Dubbo Hospital Stage 4 Redevelopment

Response to Submissions – SSD 16_7720

Figure 1 – Access and vehicle movement diagram
Source: GTA Consultants

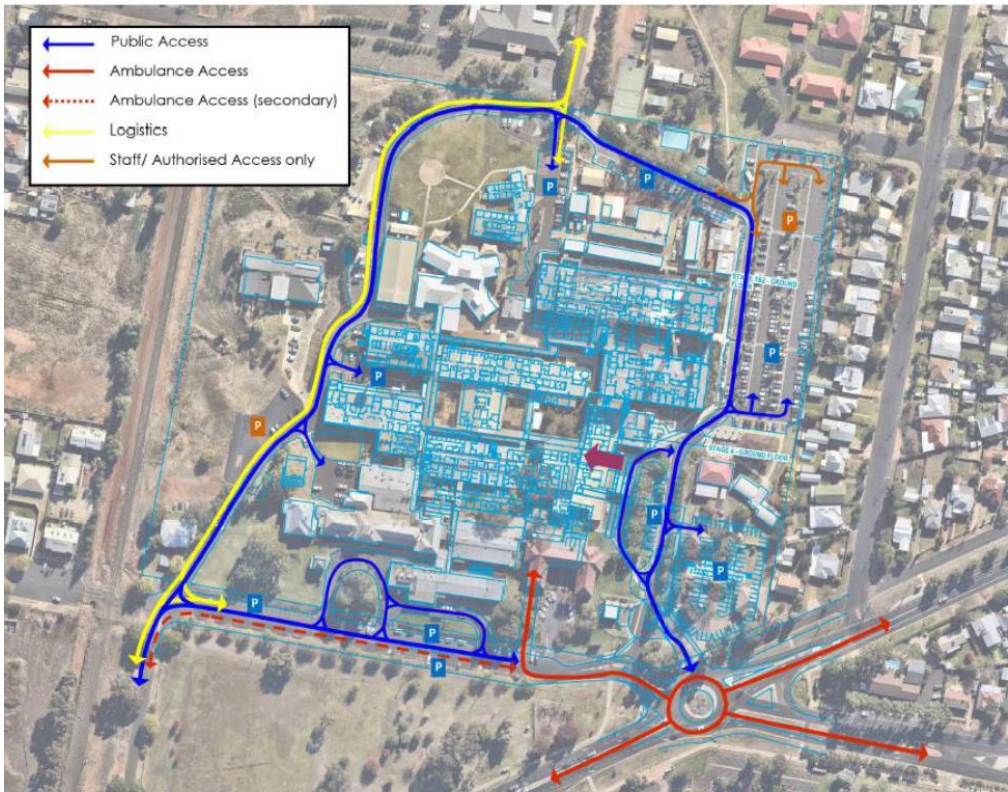
There are significant concerns which were initially flagged with the geometric realignment of Myall Street into the hospital property and intersection with Cobbora Road, and the potential traffic conflict in this locality, that have not been addressed to the satisfaction of Council. Council is disappointed that there has not been ongoing consultation on the transportation strategy and the potential opportunities available to enhance the long term accessibility needs for the Dubbo Base Hospital and the community.	
Further concerns are raised regarding the proposed Myall Street realignment and associated intersection arrangement with McGuinn Drive and to a lesser extent the new access onto the Cobbora Road roundabout in that it may not provide the optimum outcome. It is noted that it would be some time before the transportation improvements would be implemented. As such, a holistic approach should be undertaken of the Dubbo Base Hospital redevelopment, with consideration of all the mitigating factors including:

4. The proposed traffic management comprising of the Myall Street realignment, McGuinn Drive intersection and new Cobbora Road access and transition appears to promote an environment for traffic and pedestrian conflict with constrained turning paths, short travel distances for driver interpretation and decision making, no vehicle separation into Myall Street.	Refer to comments above. In response to the submissions received, and following further consultation with Council and RMS, the access arrangements off Myall Street and the Cobbora Road roundabout have been amended. As noted above, the revised layout offers a number of benefits compared to the existing access arrangements. In response to this particular concern, the identified issue of short travel distances within the hospital for driver interpretation and decision making is removed, with appropriate advanced warning and directional signage, as well as hospital identification signage, able to be provided on the adjacent road network to guide any unfamiliar users into the hospital. This would reduce the risk of vehicle conflicts.

Figure 2 – Potential Route Diversion

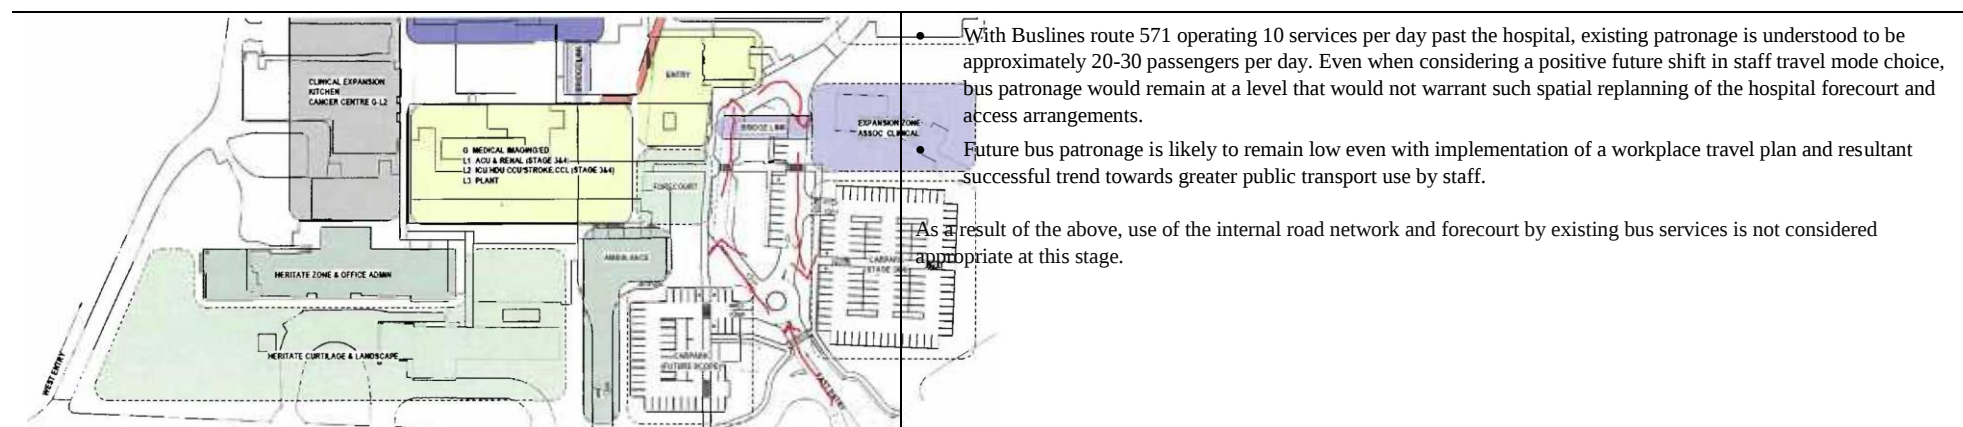
The TIA indicates that the site is within close proximity to transit stops positioned on Cobbora Road/Golden Highway. It is noted that there is no formal transit stop or supporting infrastructure at this location such as shelters or formal pedestrian connections. TfNSW would consider diverting existing bus operations via the site, if the appropriate infrastructure is made available – namely transit stops and bus capable roads. TfNSW believes that this would provide increased pedestrian safety, moreover, encouraging and attracting users of the development to utilise public transport. Figure 1, illustrates a possible diversion route through the site.	A number of bus stops are currently located along Cobbora Road in close proximity to Dubbo Hospital. This includes a bus stop (without shelter) located on the northern side of Cobbora Road immediately west of the Cobbora Road/ Myall Street roundabout and two bus stops (with shelters) on both sides of Cobbora Road east of the roundabout. All three bus stops are located within 300m of the main hospital front entrance. The bus stops are considered to be accessible being connected to the hospital by established footpaths allowing an appropriate level of pedestrian connectivity and safety. The bus stop (with shelter) located on the northern side of Cobbora Road east of the hospital also includes a pedestrian footpath connecting the east-west slip road which runs parallel with Cobbora Road. It is understood that these works were delivered as part of Dubbo Hospital Stage 1 and 2 works. As a result, it is considered that the existing bus stops and footpaths provides sufficient amenity and connectivity to the hospital and additional infrastructure is not warranted at this stage. Whilst the proposed forecourt layout has been designed to theoretically accommodate infrequent access for long haul coaches in the event that passenger ill health demands as such, frequent use by regular bus services is not recommended. GTA provide the following reasons to support this: • The function of the forecourt is to cater for a variety of users, including set-down/ pick-up of patients/ visitors, some under emergency situations. Frequent movements of large vehicles may impede this function. • Internal road alignments and widths have not been specifically designed for independent access by such large vehicles. • Swept paths included as part of the SSD Stage 4 Transport Assessment confirm that such bus access would place further constraints on the forecourt and internal roads, with several conflicts likely (refer to Attachment C). • Entering the hospital will add additional journey time to existing bus services, where existing bus stops and/ or bus shelters exist along Cobbora Road in close proximity to the hospital.

TfNSW recommends greater supporting infrastructure for safer pedestrian amenity and bus operations.

Figure 3 – Noise measurement locations
Source: Wood & Grieve

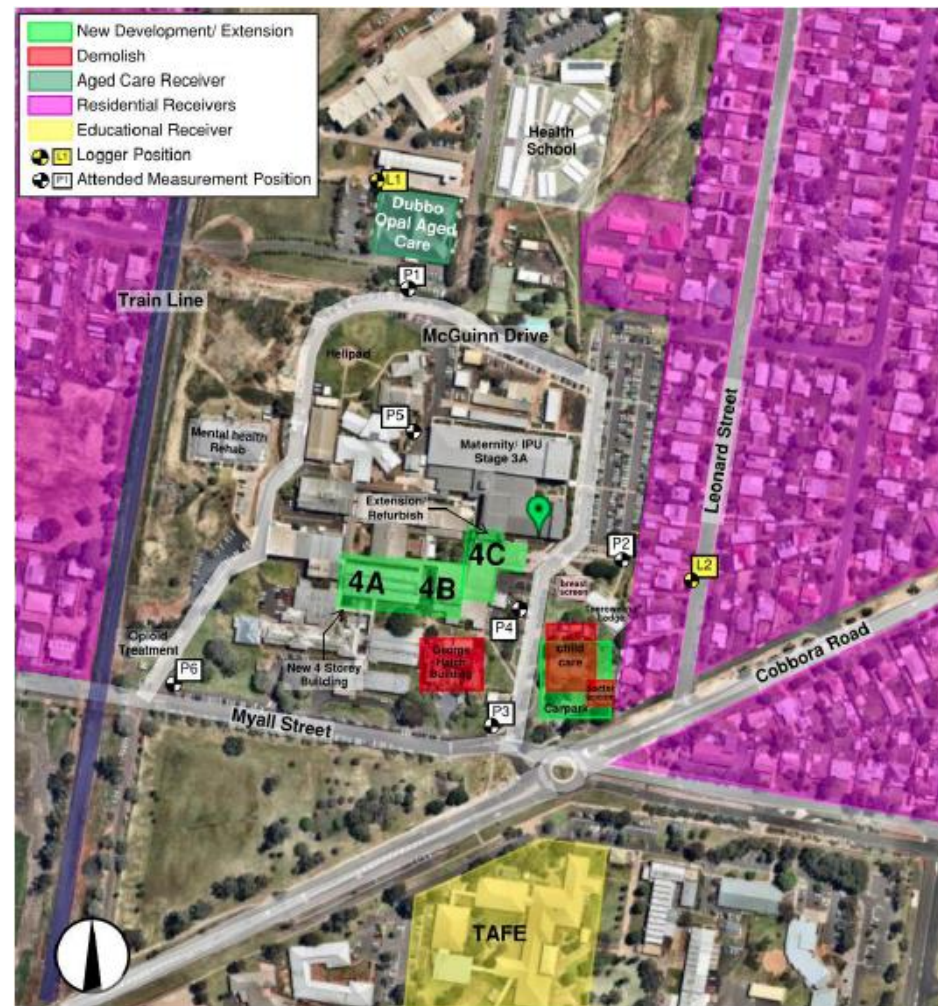
The EPA requests that the proponent be required to prepare and provide a Noise Impact Assessment (NIA) that meets the secretary's environmental assessment requirements. The NIA must include a quantitative assessment of operational noise generated by the project, in accordance with the Industrial Noise Policy: - The proponent should monitor noise levels at the nearest affected residential receivers to determine project specific noise levels in the absence of noise from the hospital site. The criteria in the acoustic report were based on measurements on the hospital site, and include noise from the hospital. Alternatively, the minimum rating background level of 30 dB(A) could be adopted, leading to a project specific noise level of $L_{eq(15\ min)} 35\ dB(A)$ at all times of day. - The proponent needs to demonstrate, through appropriate modelling and in accordance with the Industrial Noise Policy, that the project will meet the project specific noise levels at sensitive receiver locations. The acoustic assessment listed operational noise and vibration criteria for the project, but did not adequately assess the project against those criteria. - If the project specific noise levels are not met the proponent needs to demonstrate that the predicted levels include all feasible and reasonable mitigation measures, and that there are no other feasible and reasonable mitigation measures available.	An Operational Noise Impact Assessment has been prepared to assess the operational noise generated by the project in accordance with the INP. Attended noise measurements were undertaken on the site to capture typical noise environments in and around the hospital, characterise the traffic noise local to the site (P3, P4, P5 and P6) and attain a background noise spectrum adjacent to the nearest sensitive residential receivers (P1 (Dubbo Opal Aged Care) and P2). Unattended noise measurements of existing ambient noise levels (L1 and L2) were also undertaken. The unattended measurements were the second instance of noise monitoring at the boundary of nearby receivers, undertaken as a direct response to the requirement to “<i>determine project specific noise levels in the absence of noise from the hospital site</i>”. The location of the noise measurements is shown in Figure 3 below. The noise measurement data is documented within the NIA (Attachment E). The INP Intrusiveness and Amenity Criteria have been applied to the background noise levels to determine the project specific noise levels (PSNL). The PSNL adopts the more stringent criteria for each period. The PSNL are shown in Table 3 below.

2. The noise emissions from the operation of the hospital have been modelled in SoundPLAN 7.4. Two situations were assessed, one for day time assuming all equipment is operating, and a night time assessment using only the plant equipment selected as operational during the night time period. Sound pressure levels for daytime and night time operation at nearby receivers are provided in **Table 4** below.

Following detailed analysis of the environmental noise modelling for the Stage 4 development, it is concluded that the design for the building, including increase in vehicle movements, will not exceed the PSNLs set out by the INP at the nearest worst affected receivers. The primary noise contributors to receivers are the cooling towers located outside of the level 3 plant room. The acoustic modelling assessment has been conservative in assessing noise transmitted over the cooling tower enclosure, rather than through the barrier. Based on information from the mechanical engineer detailing plant equipment operational during the night time period, it is shown that noise intrusion to the façade of the nearest residential receivers will not exceed the 38 dB(A) night time criteria provided that the surrounding enclosure is implemented. Day and evening time operational noise criteria (45 dB(A)) will not be exceeded at residential receivers. Education receivers at the southern TAFE site have assumed a 10 dB sound reduction between the façade and the internal classroom to meet the 35 dB(A) internal noise criteria. The opioid treatment facility at 170 Myall Street has been considered a commercial premise, and as such has a higher noise criteria of 65 dB(A) which is predicted to comply with the criteria at all times. 3. The recommended mitigation measures relate only to the cooling tower. It is uncertain at this time the material of the cooling tower enclosure, however based on the findings of the NIA it is recommended to achieve a minimum Rw 25 performance to ensure sound transmission through the barrier is no greater than the sound contribution from over the barrier.
